AGENDA
City of Dallas
Planning Commission
Tuesday, June 11, 2024 - 7:00 p.m.
City Hall Council Chambers
187 SE Court Street

**CITY OF DALLAS
PLANNING COMMISSION
STAFF REPORT**

COVER SHEET

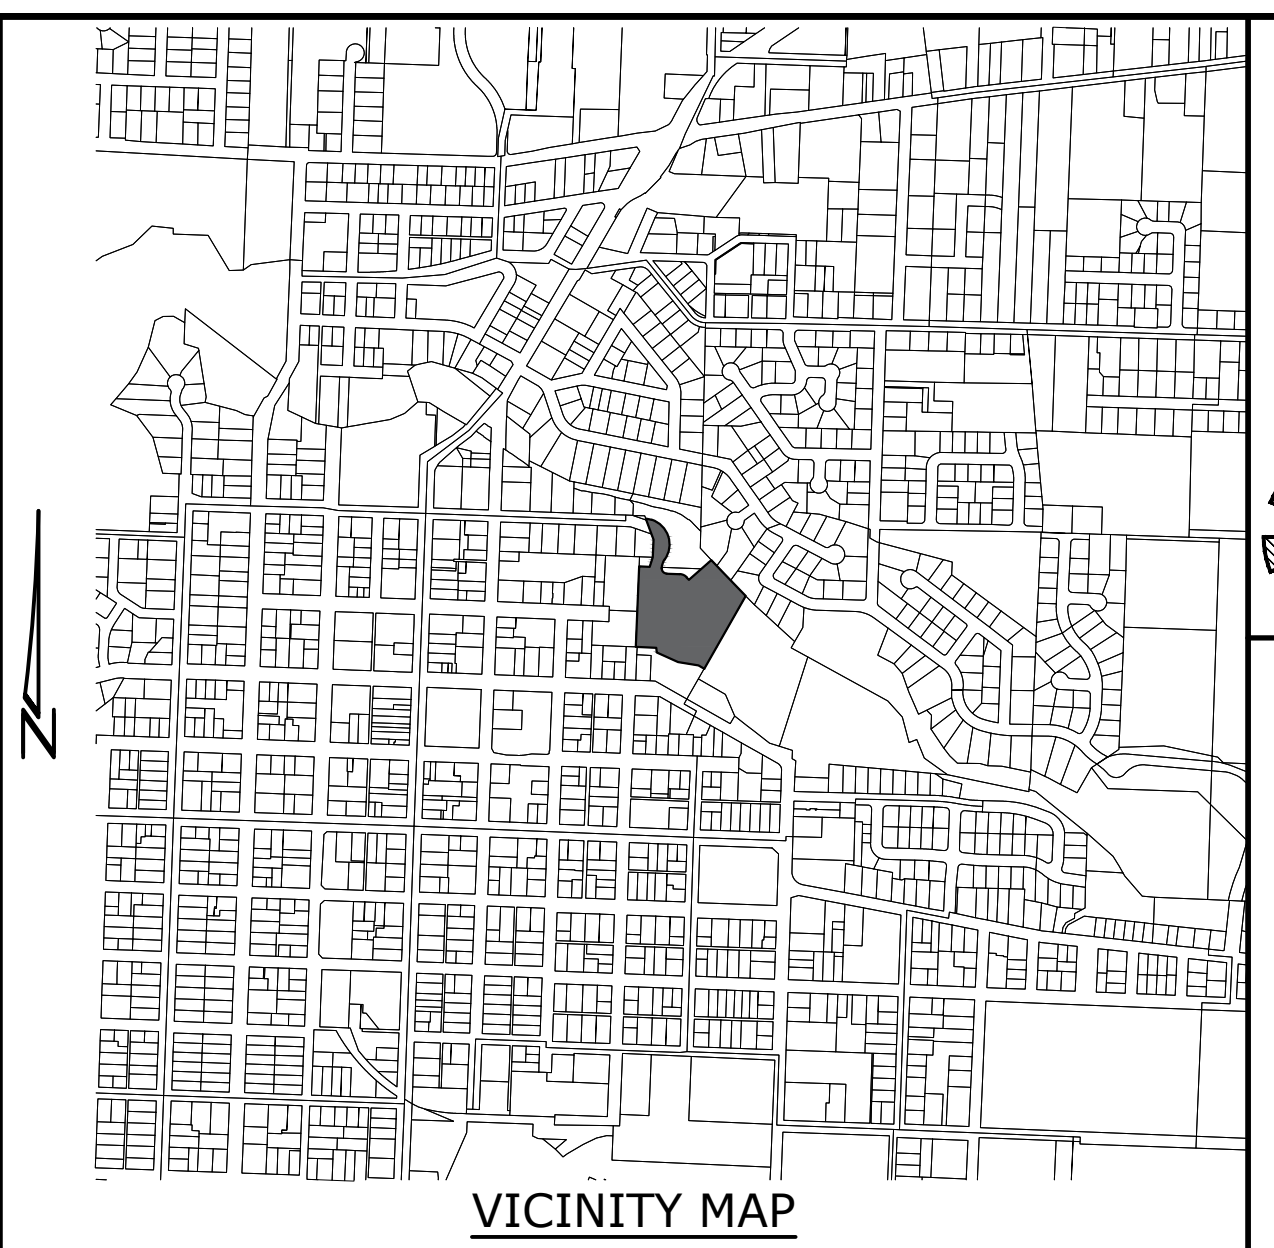
The applicant's Sheet P101, Cover Sheet, shows the proposed 25 lots and that the lots at the corners of intersecting public/private streets (Lots 5, 6, 20 and 23) are of adequate size for their driveways to be separated a minimum of 50 feet from the intersections. The north/south dimension of Lot 5, at the intersection of SE Academy Street and SE Oak Street, is 63.92 feet, thus the driveway would need to be near the north property line. The east/west dimension of Lot 6, at the intersection of SE Academy Street and SE Oak Street, is 77.32 feet, thus the driveway would need to be near the west property line. The east-west dimension of Lot 20, at the intersection of SE Academy Street and a privately-owned 20 foot wide mid-block lane, is 90.00 feet, thus the driveway would need to be near the east property line. The east/west dimension of Lot 23, at the intersection of SE Academy Street and SE Oak Street, is 55.45 feet from the apex of the intersection arc to the east property line, thus the driveway would need to be near the east property line.

EXPIRES: 06-30-2025
JOB # 6706
P401

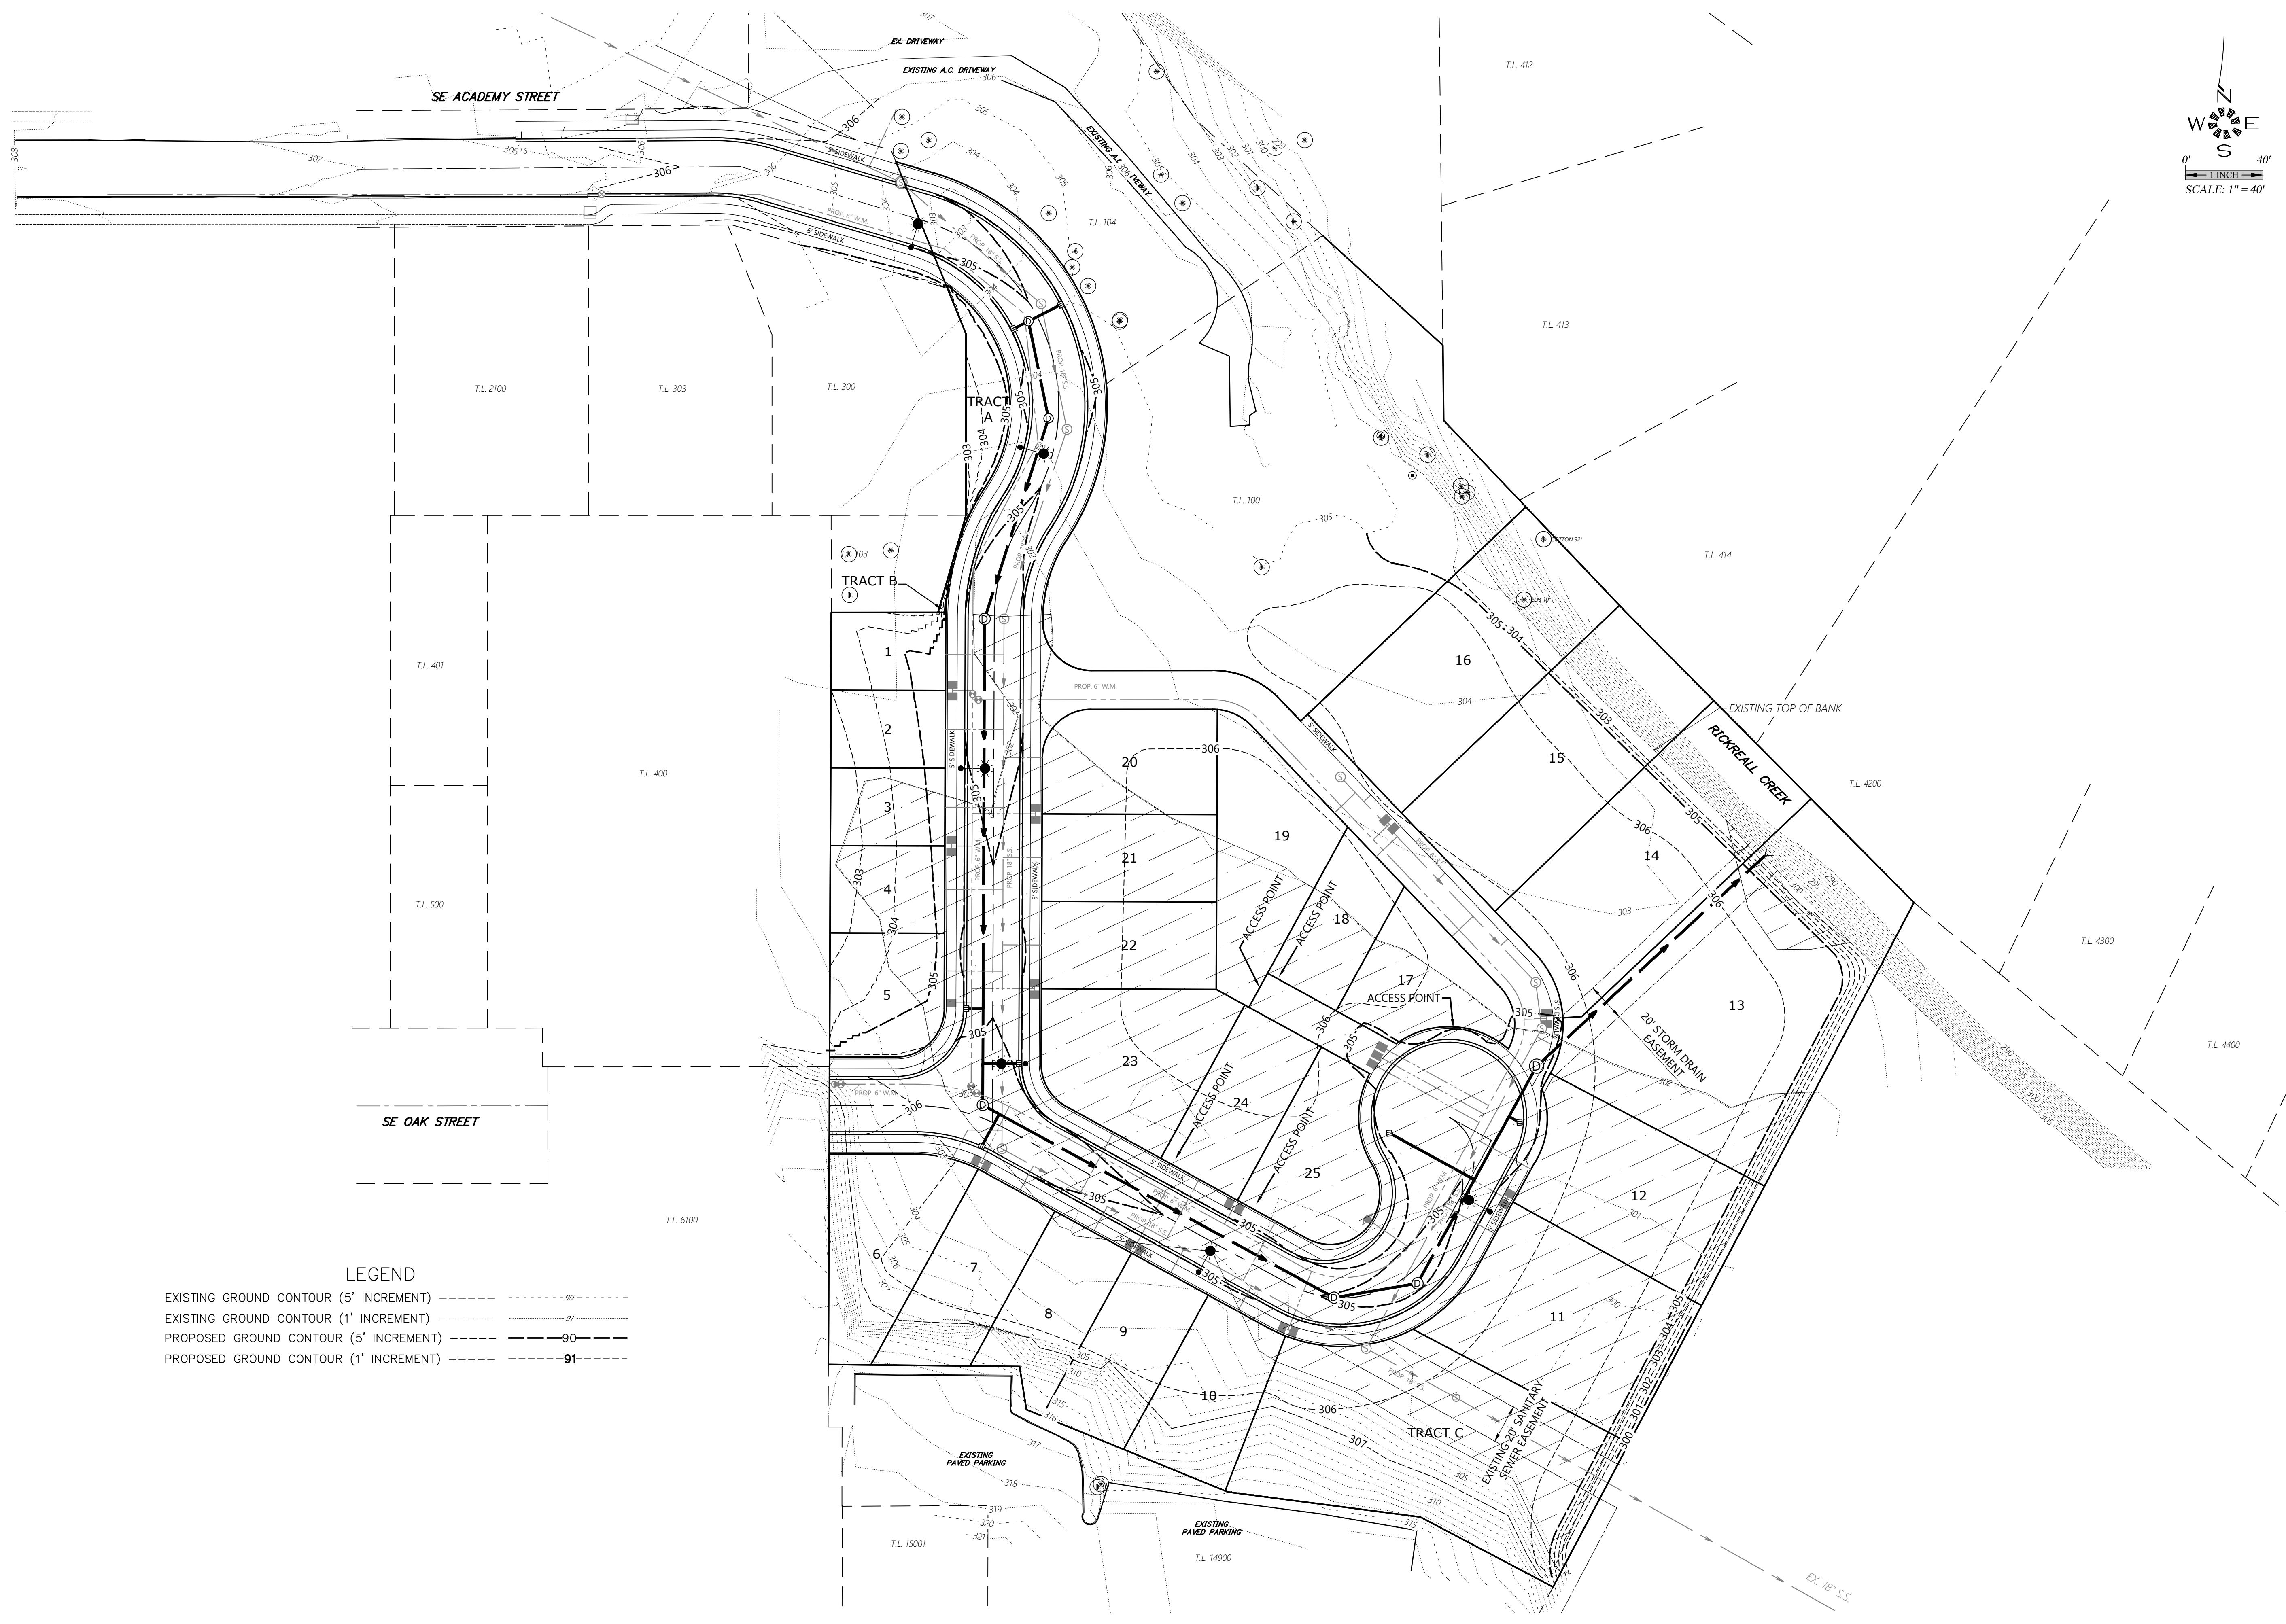
The applicant's Sheet P401, Grading Plan, includes labels (an arrow and "Access Point") showing the approximate driveway access location for Lots 17, 18, 19, 24 and 25. The driveway for Lot 17 is along the cul-de-sac bulb approximately equidistant from the privately-owned mid-block lane extending north (and curving northwest) from the cul-de-sac and the privately-owned mid-block lane extending northwest from the cul-de-sac. It is not clear the proposed driveway for Lot 17 is at least 50 feet from either of the mid-

block lanes. A condition of approval (**Condition of Approval 2, g**) requires the Final Plat to show Lot 17 is capable of providing a driveway a minimum of 50 feet from the mid-block lanes to the east and west.

The driveways for Lots 18 and 19 are proposed to enter onto the northwest end of a 20 foot wide by approximately 75 foot long privately-owned mid-block lane extending northwesterly from the cul-de-sac. The points where the driveways for Lots 18 and 19 would enter the end of the mid-block lane would be separated from the cul-de-sac by more than 50 feet. The driveways for Lots 18 and 19 are proposed to share the mid-block lane. A condition of approval is not recommended that would require the Final Plat to show the mid-block lane as a Tract with a joint maintenance agreement for shared driveways because Condition of Approval 2, b, requires a revised Final Plat be submitted showing a public street without a cul-de-sac or mid-block lanes.

The capability of the subdivision's lots to accommodate driveways compliant with the minimum 50 foot separation will be reviewed when the Final Plat is submitted for approval. The minimum 50 foot separation will also be reviewed for compliance at the time of building permit submittal. The driveway locations may change with the reconfiguration necessitated by replacing the cul-de-sac and the mid-block lanes with an extension of SE Academy Street and the dedication (fee simple or an easement) for the Rickreall Creek Trail.
